FIELD SERVICE CAMPAIGN – 19112

Rerouting and Clipping of Aftertreatment Harness.

International® MV™ Series

Figure 2. Incorrect Harness Routing

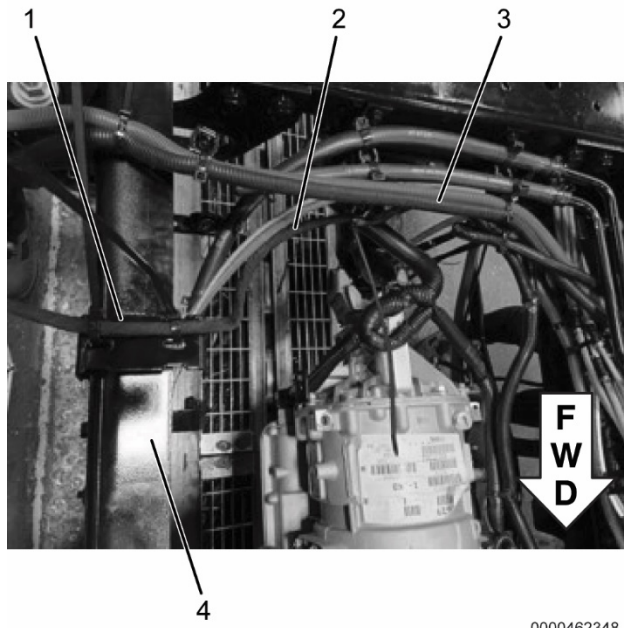
The Aftertreatment (AFT) harness may be improperly routed and under certain conditions, the cab may contact the AFT harness resulting in chafed or damaged wires.

NOTE: Figure 2 depicts incorrect routing of Aftertreatment harness. Harness (Figure 2, Item 2) contacts underside of cab (Figure 2, Item 1).

Figure 3. Correct Harness Routing

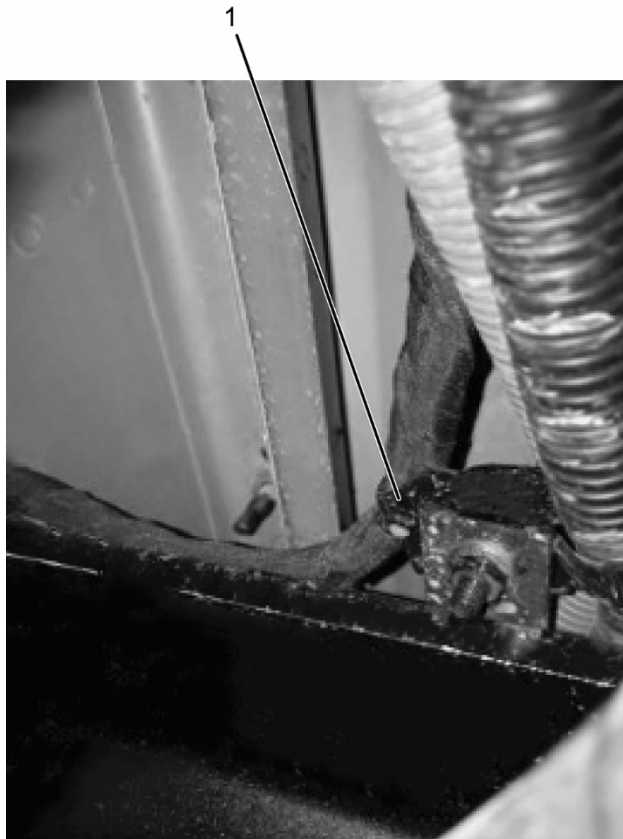
NOTE: Figure 3 depicts correct routing of Aftertreatment harness. Harness (Figure 3, Item 2) is aligned with and mounted to support bracket (Figure 3, Item 1) and does not contact underside of cab.

1. Cable tie strap
7. Remove cable tie strap (Figure 4, Item 1) securing harness to frame.
8. Inspect harness for any rub marks or frame contact.
 - a. If harness damage is found, refer to iKNow article IK0800269 for proper wire repair; proceed to Step 9.
 - b. If no damage is found, proceed to Step 9.
9. Reroute harness away from DEF lines (Figure 3, Item 3) and over frame rail (Figure 3, Item 4).
10. Using cable tie straps, fasten harness to support bracket (Figure 3, Item 1).
